## APA Technical Note - Western Outer Ring Main - Environment Effects Statement

**TECHNICAL NOTE NUMBER:** TN08

**SUBJECT:** Alignment/Design Changes - Update to Pipeline Licence Application and Response to Inquiry RFI 3, 5 and 6.

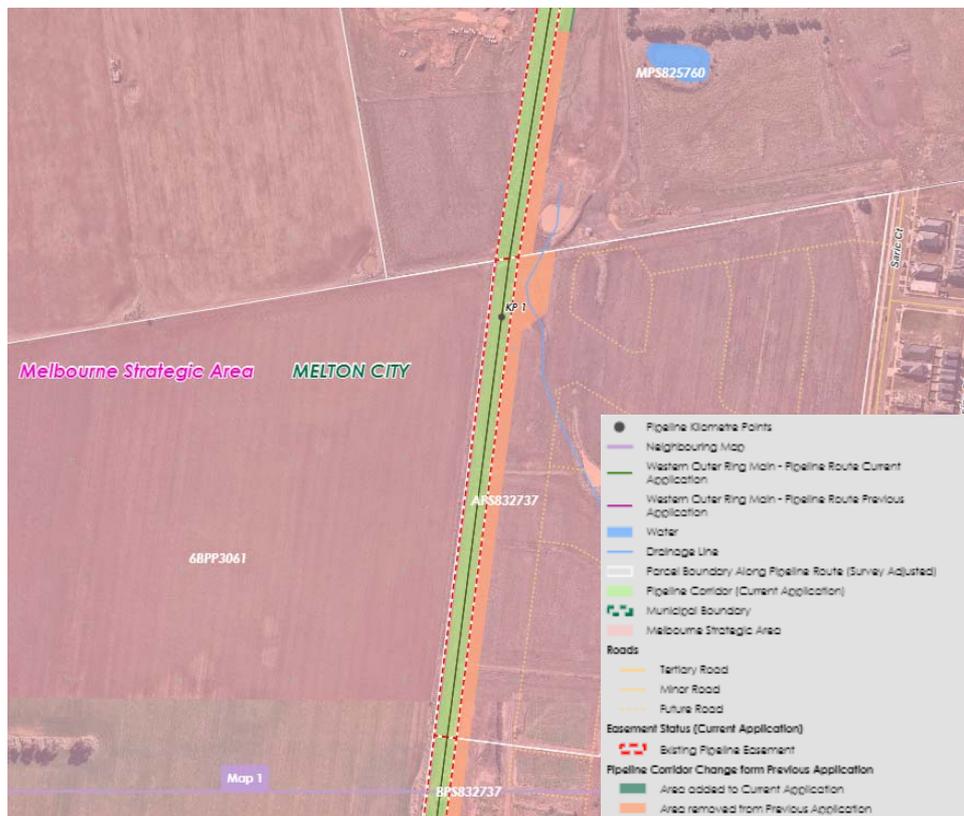
- 5 The route refinements that were under consideration at Oaklands Road (KP 20) and Mickleham Road to the north of Donnybrook Road (KP 28 to 32) have been finalised and

are included in Revision 10 of the Pipeline Alignment, as shown in the attached Amended Mapbook. The changes are discussed in paragraph 7 (h) and (m) below.

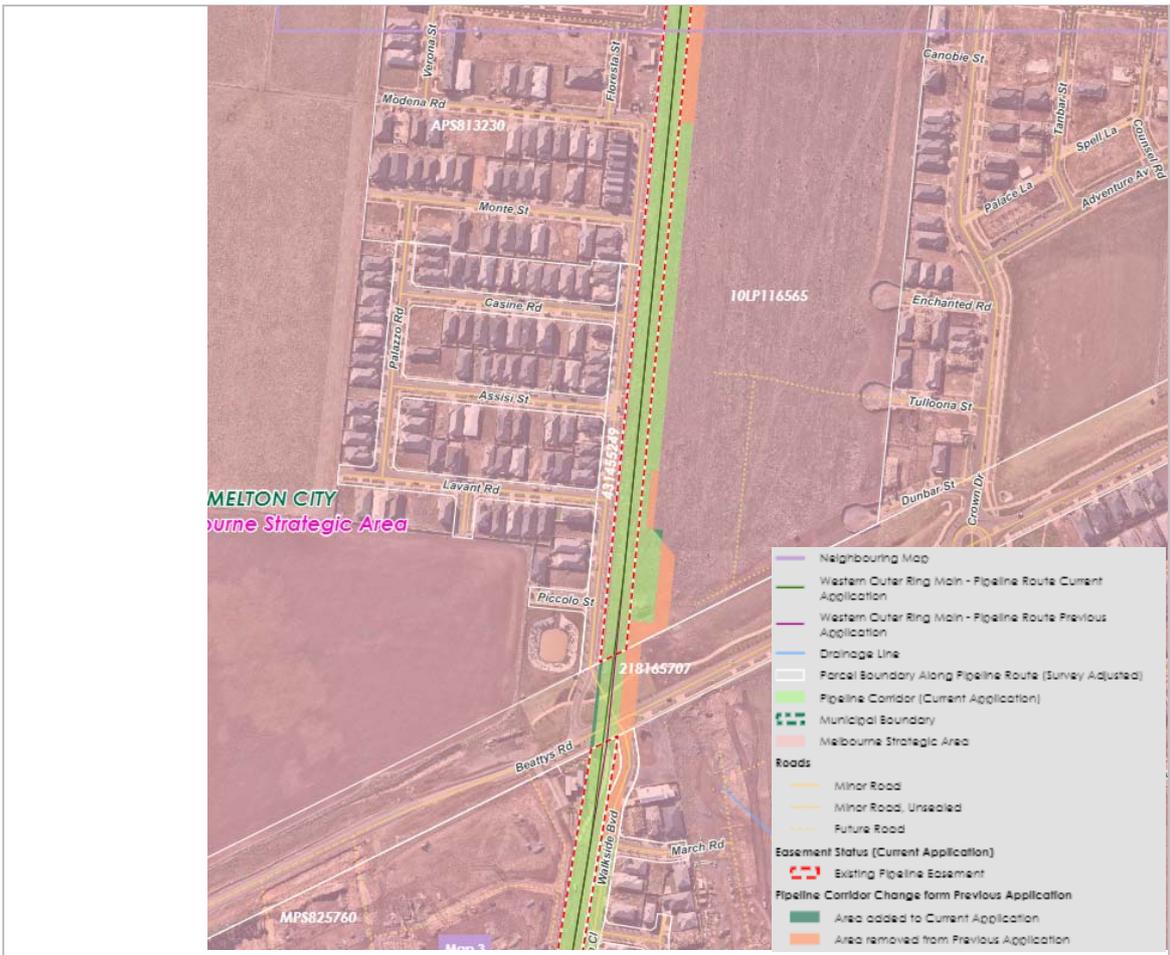
- (a) KP 0 to KP 1.07: Pipeline corridor reduced by 1.22 hectares (ha) at the request of the land developer to allow for concurrent construction activities to occur between APA and the land developer within this area of the Plumpton Precinct Structure Plan (PSP).

- (b) KP 1.07 to KP 1.57: Pipeline corridor increased by 0.24 ha to compensate for reduction between KP 0 to KP 1.07. This increase is to ensure there is sufficient temporary construction space to safely install the pipeline in this area.

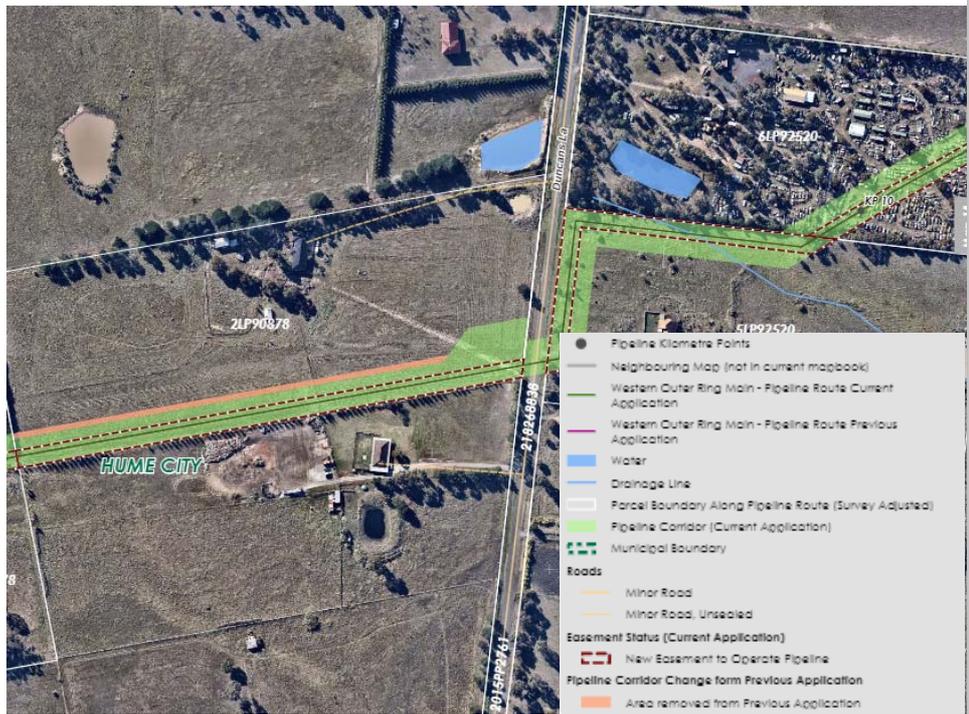
- (c) KP 2.21 to KP 2.97: Pipeline corridor redesigned to reflect boring construction method. This resulted in a reduction in pipeline corridor across Beatty's Rd and a minor increase north of Beatty's Rd due to the location of a bend. Reduction of pipeline corridor in the northern portion of this property was made at the request of the land developer to allow for concurrent construction activities to occur between APA and the developer within this section of the Plumpton PSP.

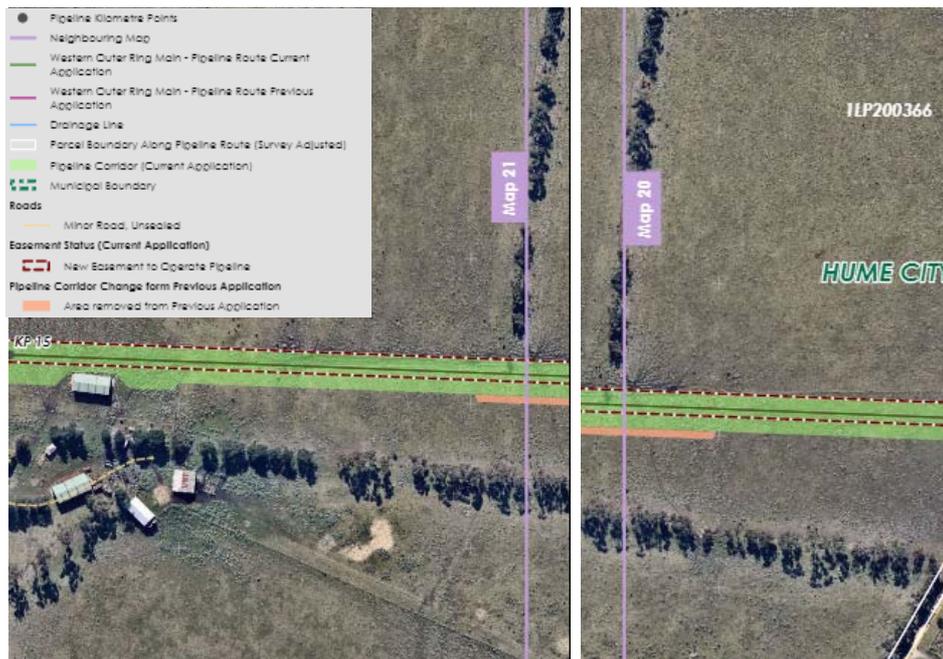
(d) KP 9.16 to KP 9.54: Pipeline corridor reduced by 0.19 ha to minimise environmental impacts, specifically clearing of potential Striped Legless Lizard habitat.

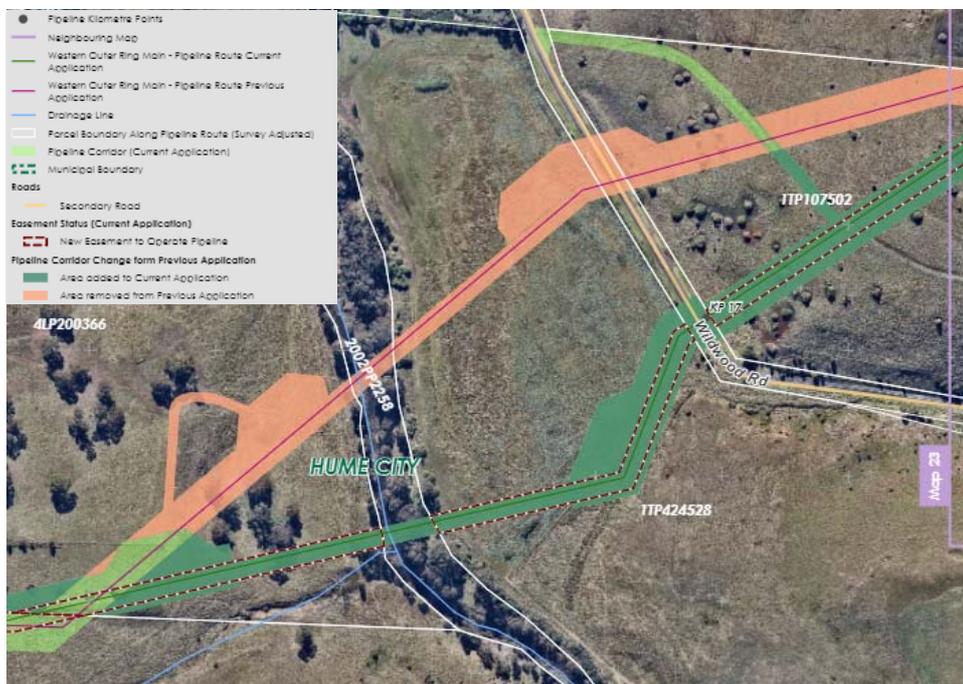
- (e) KP 15.3 to KP 15.4: Pipeline corridor reduced by 0.05 ha to minimise impact to native grasslands.

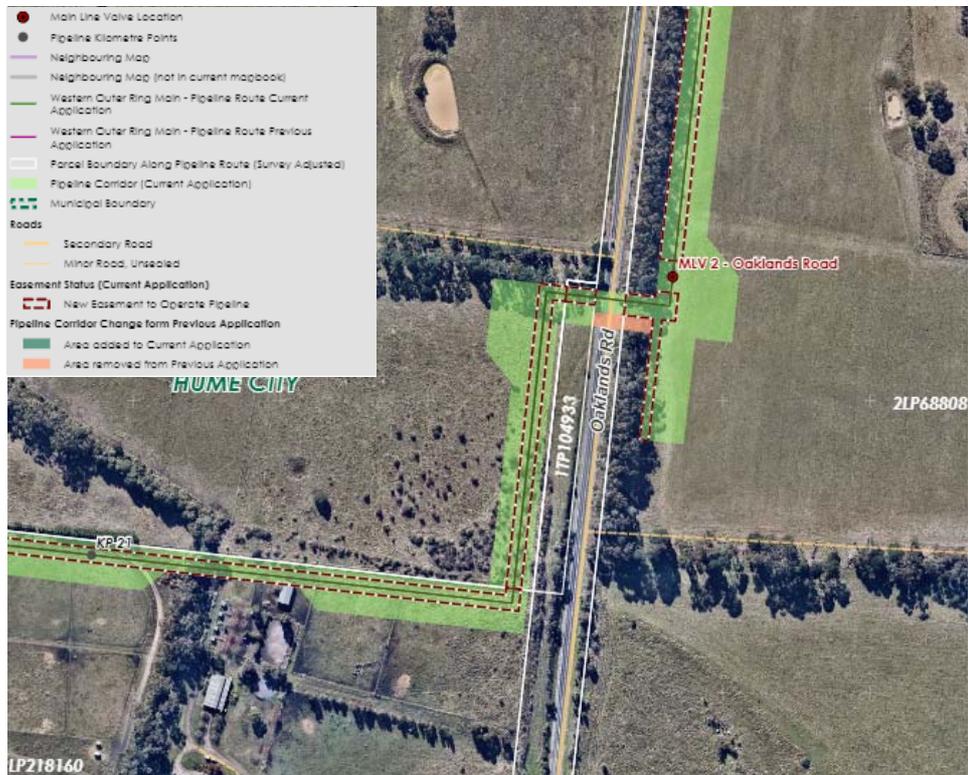
- (f) KP 16.3 to KP 17.3: Pipeline corridor redesigned at Deep Creek at the request of the landowner to minimise impact to flatter land within property to the north.

- (g) KP 17.32 to KP 18.32: Pipeline corridor revised at the request of the landowner to minimise impact to dam within property.

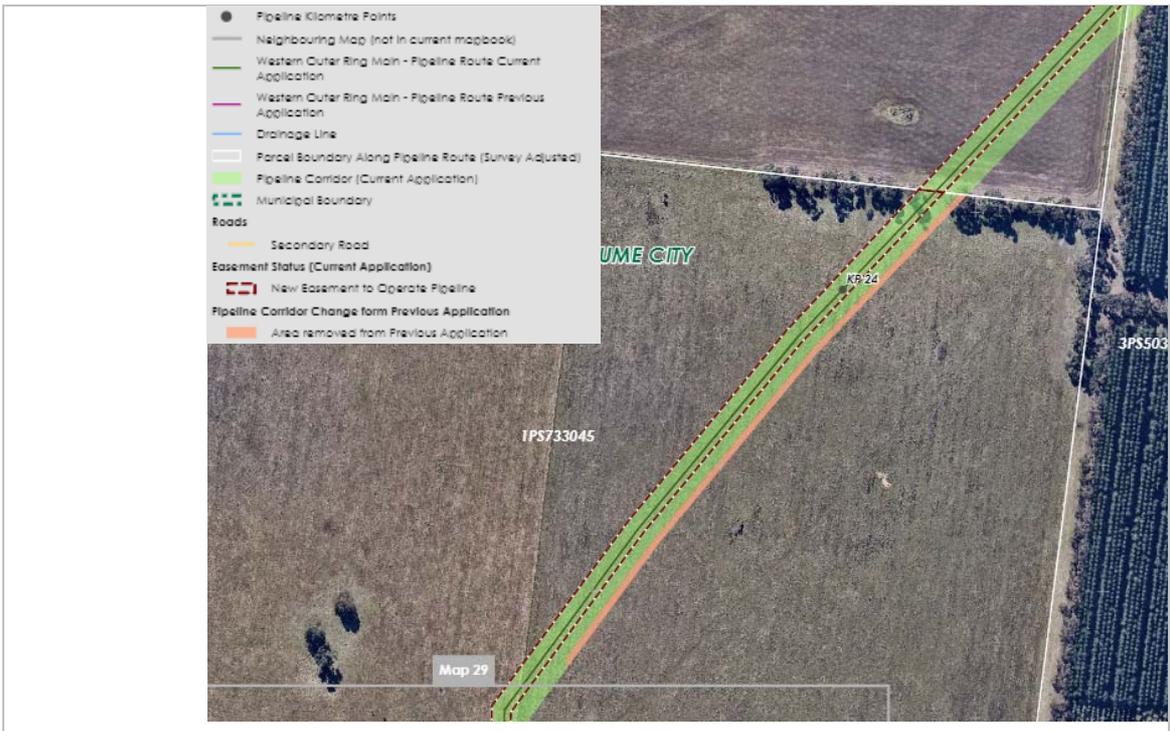
(h) KP 19.24 to KP 20.88: Pipeline corridor redesigned at the request of Department of Transport (DoT) to minimise interface with Outer Metropolitan Ring (OMR) corridor.

- (i) KP 21.66: Pipeline corridor redesigned and reduced across Oaklands Road to avoid impact to tree line.

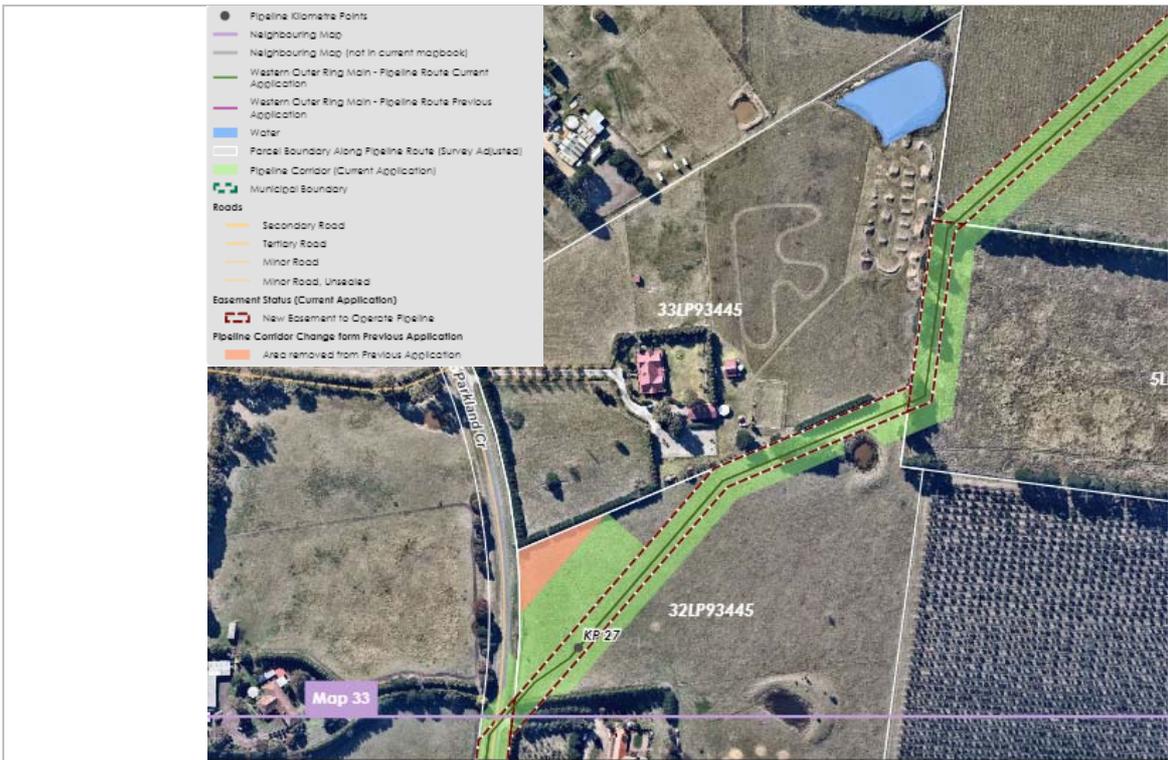
- (j) KP 23.70 to KP 24.17: Pipeline corridor reduced by 0.24 ha to minimise environmental impacts, specifically clearing of potential Golden Sun Moth habitat.

(k) KP 25.97 to KP 26.35: Pipeline corridor redesigned at the request of the landowner to reduce orphaned land along road boundary while maintaining an area of screening vegetation.

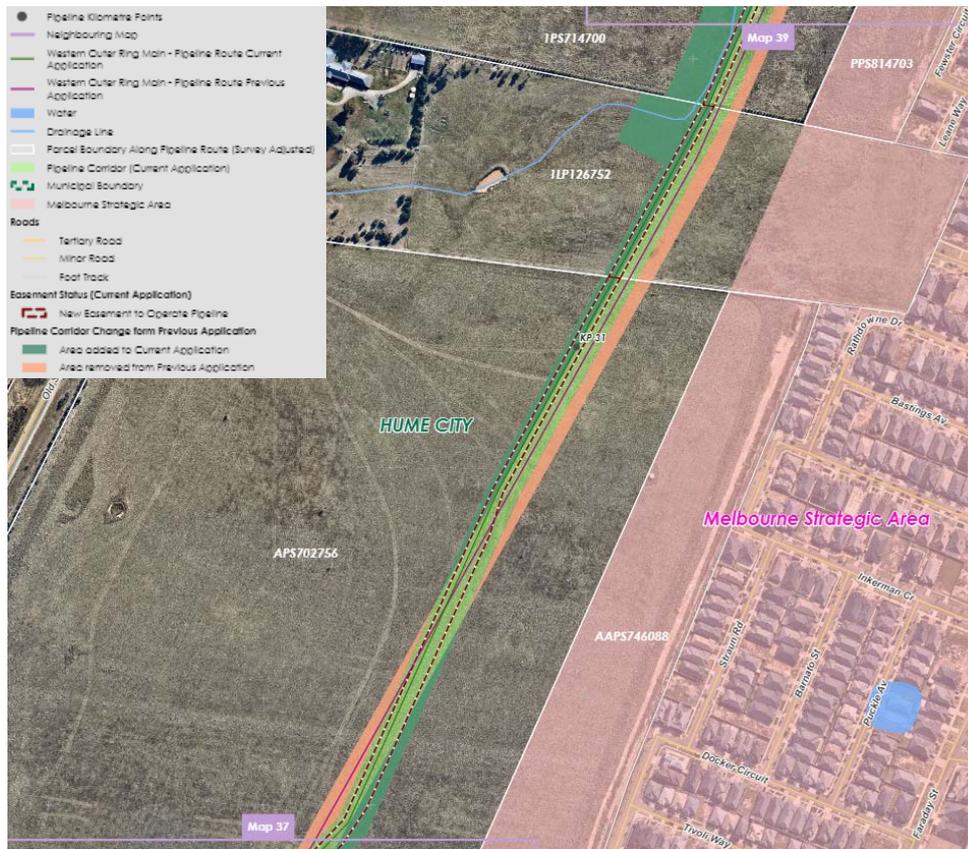
(l) reduced to minimise environmental impact.

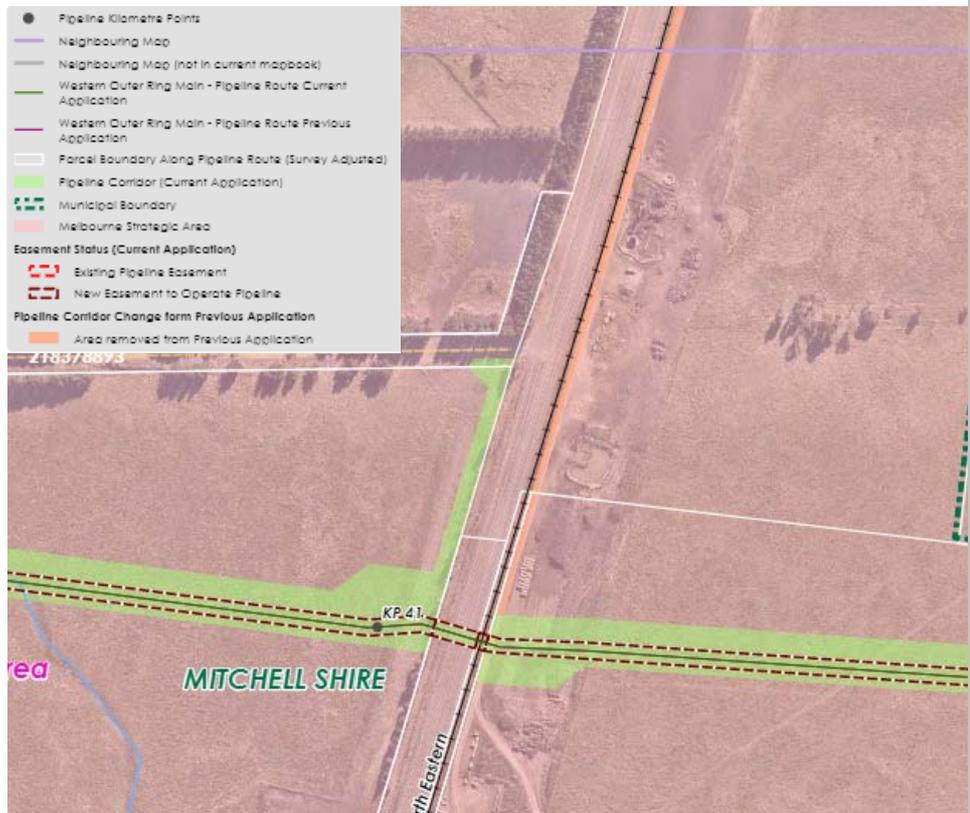
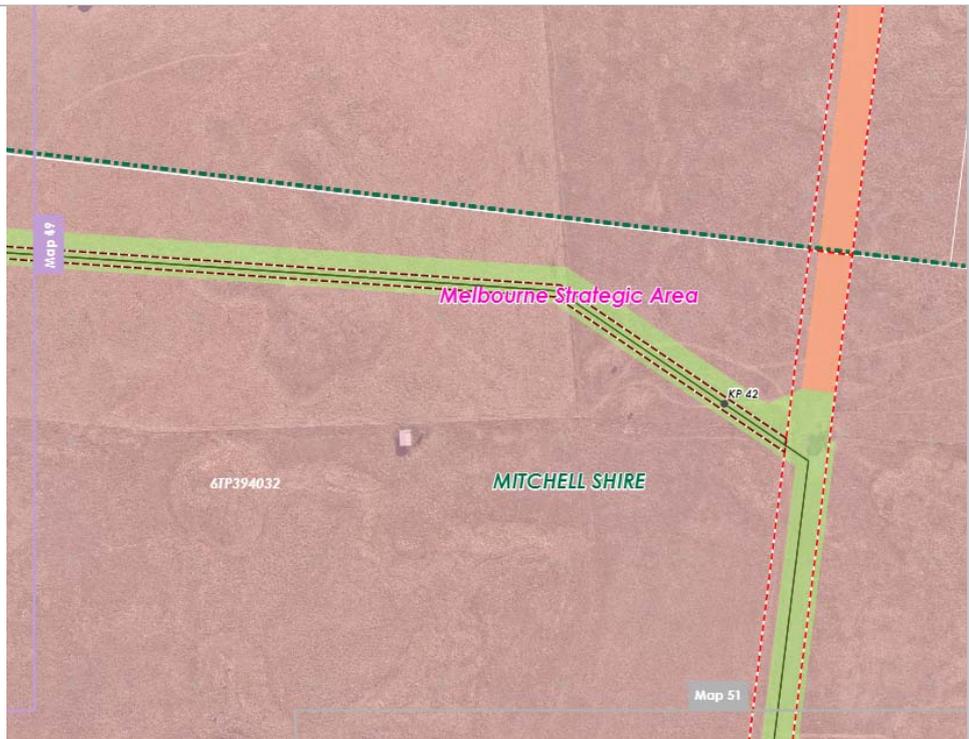
(m) KP 30.30 to KP 32.0: Pipeline corridor redesigned at the request of DoT to minimise interface with OMR corridor.

(n) KP 34.89: Pipeline corridor increased to include additional area within road reserve for access to Main Line Valve 3 site.

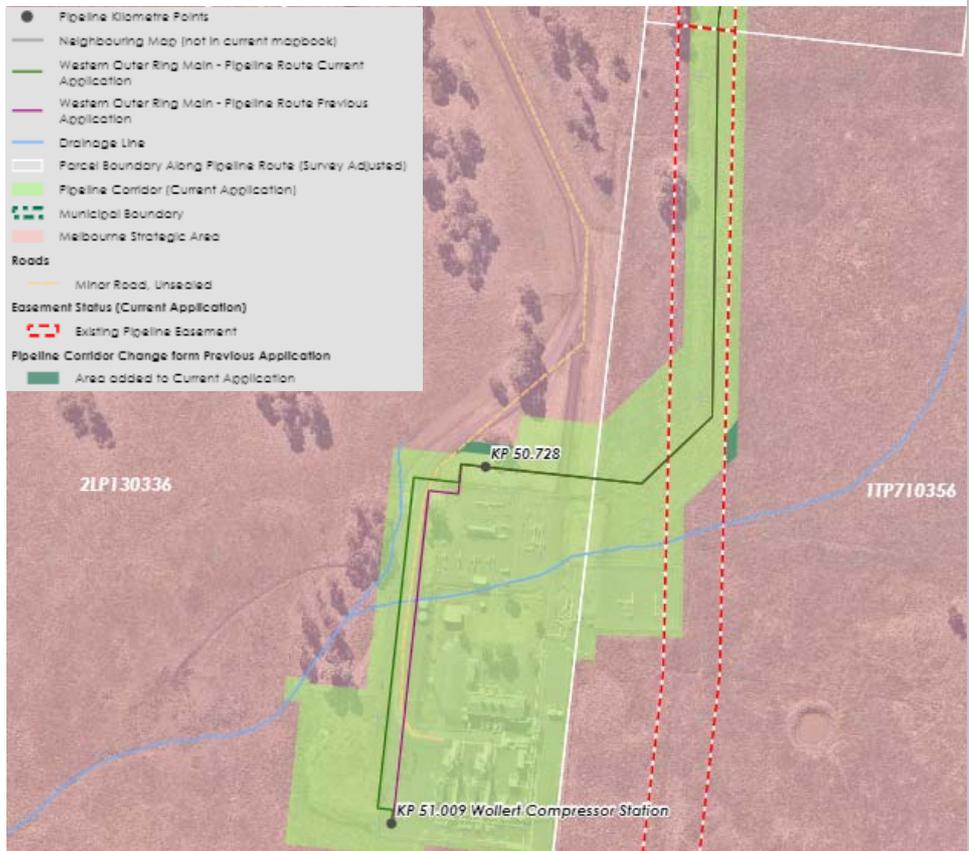
(o) KP 41.16 & KP 42.13: Potential pipeline corridor access tracks removed as access can be obtained from the south.
